# PECO NUCLEAR

**SUBJECT:** Limerick Generating Station, Units 1 and 2  
Response to Request for Additional Information Regarding Review of  
Individual Plant Examination of External Events

Response to Request for Additional Information  
Limerick Generating Station, Units 1 and 2  
Individual Plant Examination of External Events (IPEEE)

Figure S4.1

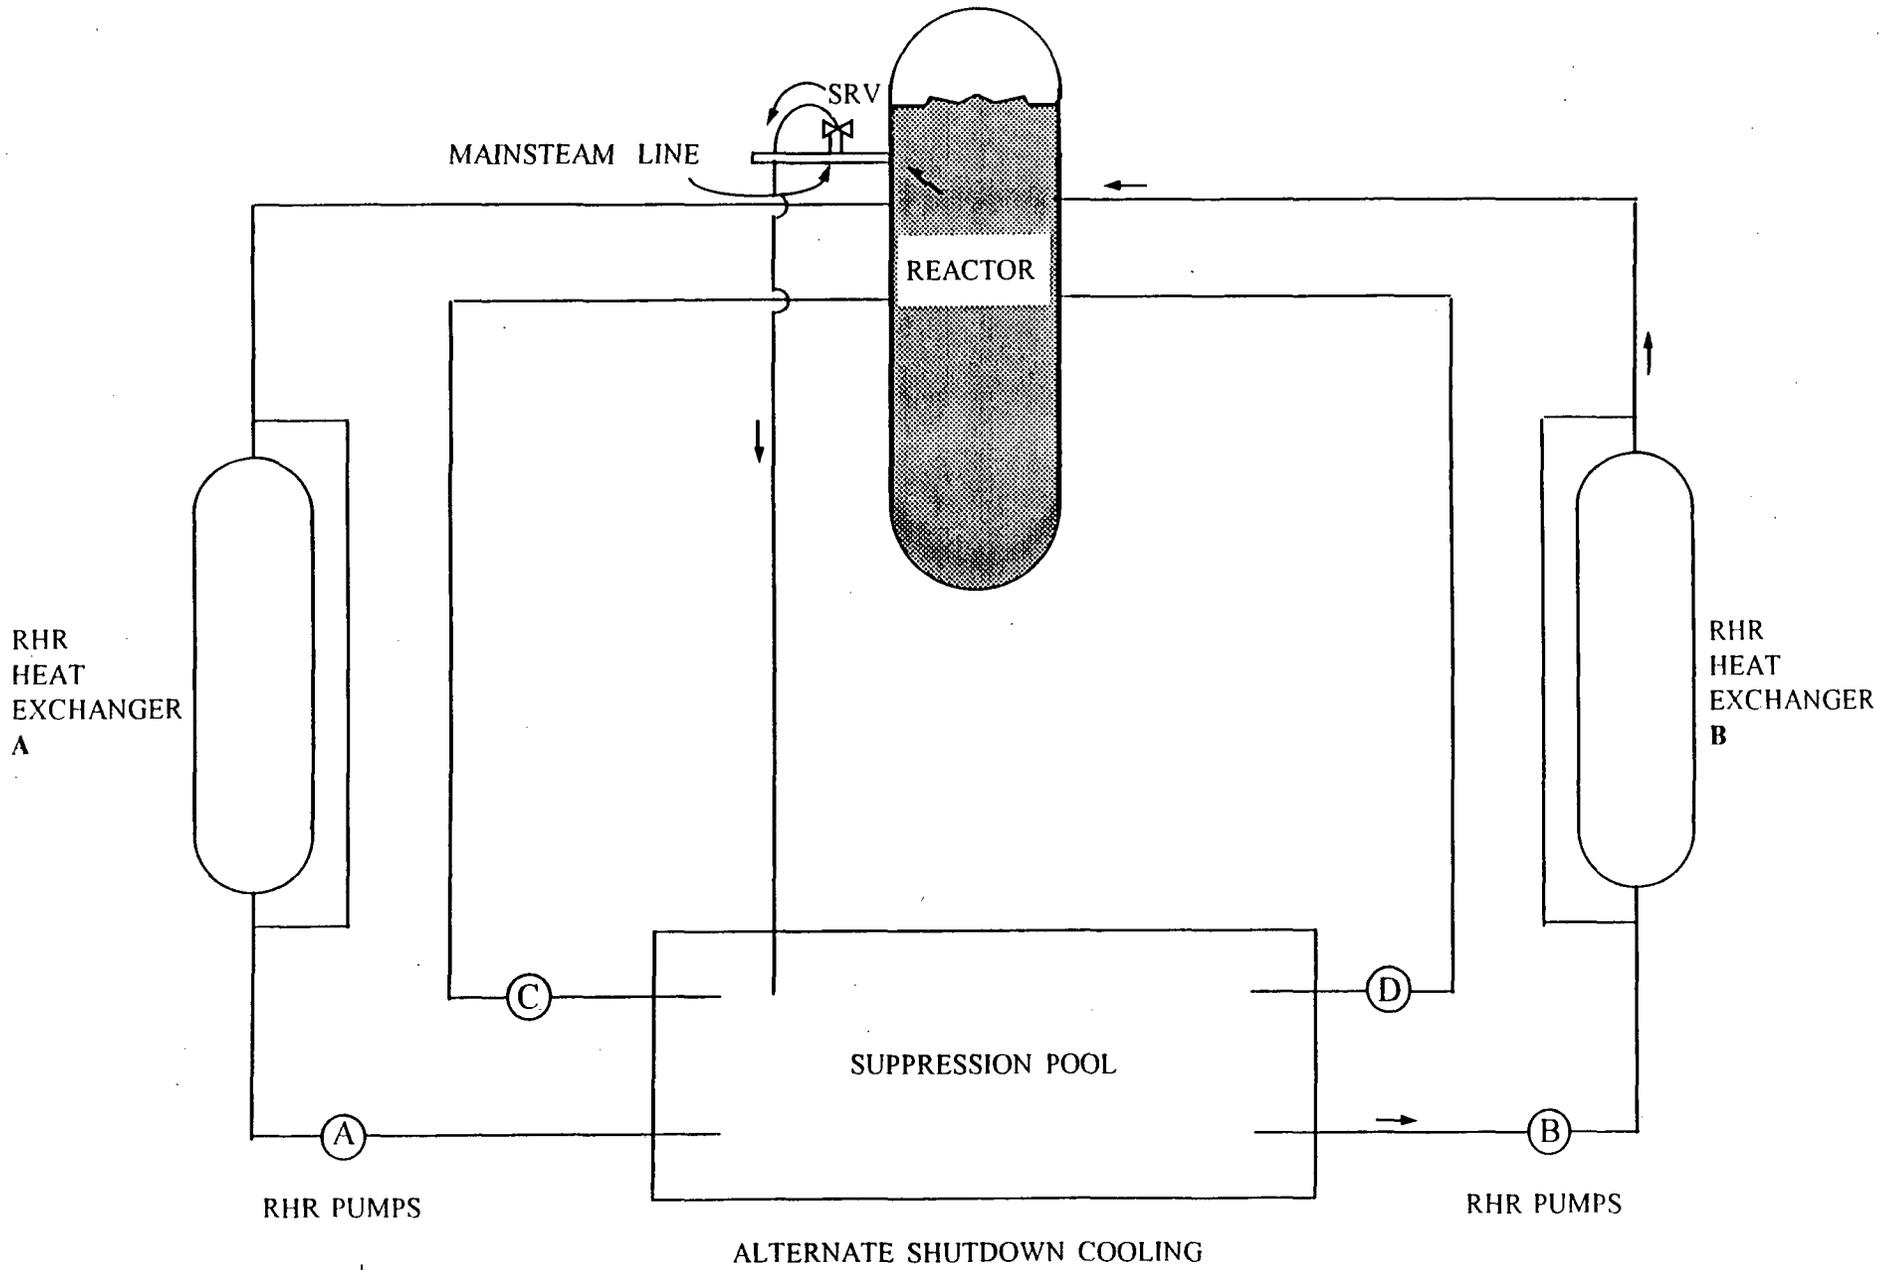
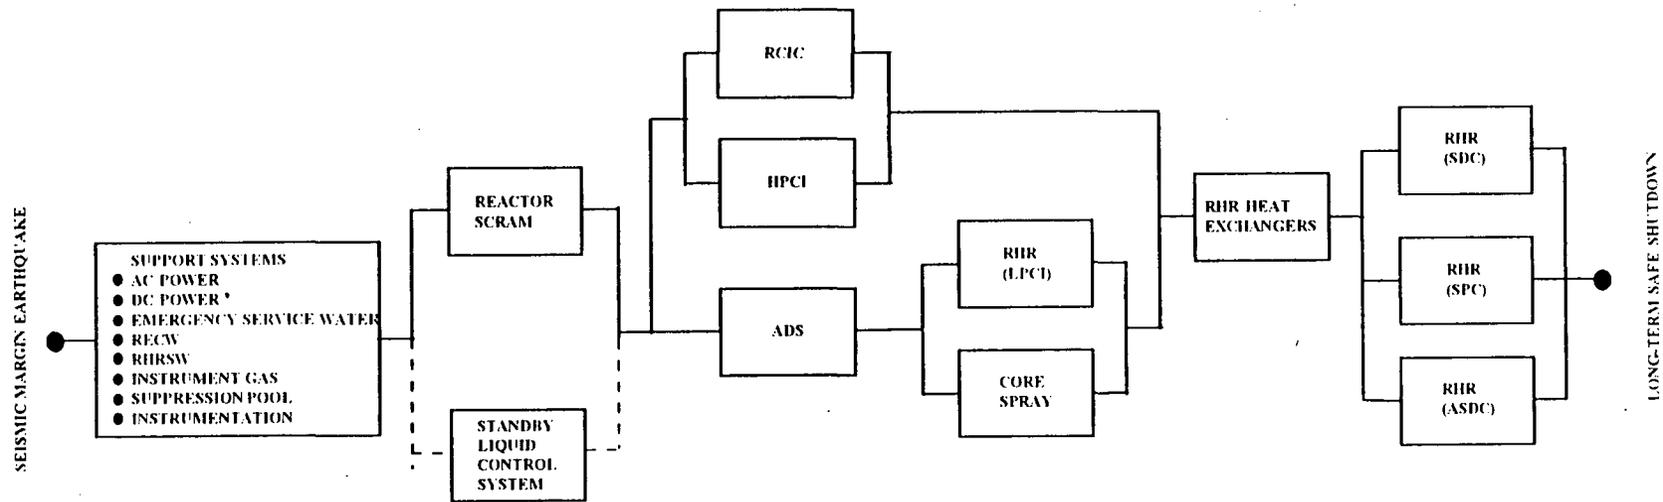
4. Provide a copy of the "Success Path Logic Diagram" (SPLD) which is referred to in Section 3.1.2.5.4.1 of the IPEEE submittal report.

4. Figure S4.1 (attached) is the SPLD for Limerick.
